# H TECHNICAL BULLETIN

## HT SERIES, INTRAAX TRAILER AIR SUSPENSION PIVOT CONNECTION FASTENER UPGRADE

No: TRAILER AUS - 015  
Subject: *Product Update*  
Date: July 1999 Revision: A

Figure 2. New Pivot Connection Hardware  
**Part No. S-24679**

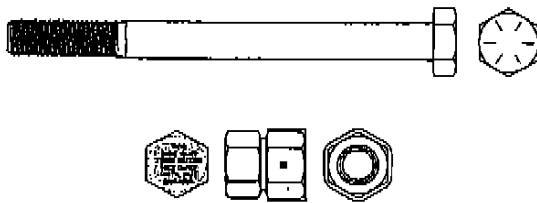
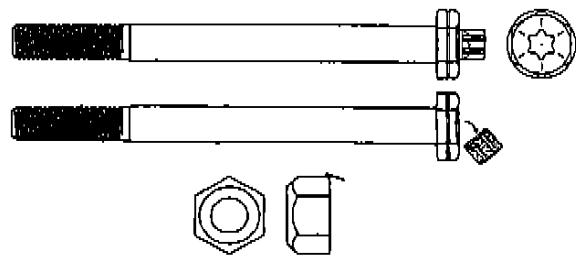
As part of our continuous product improvement program, Hendrickson has revised the pivot connection bolt.

Effective August, the bolt and, "TORQ-RITE" nut will be replaced with a shear-head bolt and prevailing nut. This will permit flexibility when installing the, "QUIK-ALIGN" arrangement on the suspension.

Because torque requirements vary between the existing and new pivot connection hardware, do not mix the current style with the new revision.

The shear bolt is a convenient feature to achieve the correct clamp load without the use of a torque wrench. Hendrickson designed and tested the shear-head bolt and nut to maintain the proper clamp load during the lifetime of the trailer.

*Figure 3. Flash on the new pivot connection bolt*

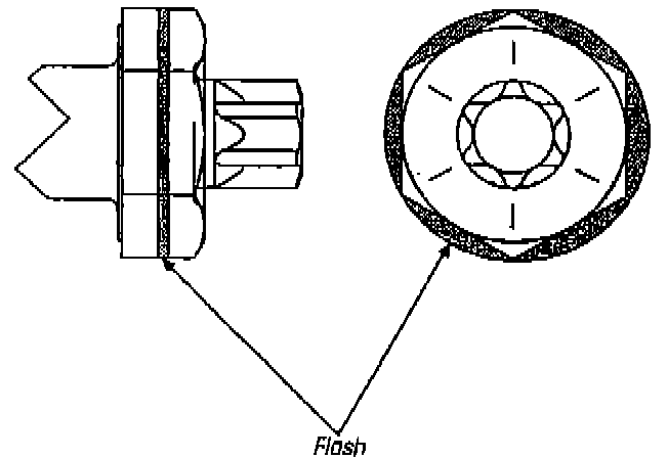
To reuse the shear head bolt, the repairer must grind or chisel off the flash (the excess metal around the sides of the hex head) from the bolts head. (figure 3) To ensure proper performance and clamp load the connection must be re-tighten to a torque of 550 ft-lbs. Failure to achieve the correct clamp load may result in damage to the suspension and adjoining components.
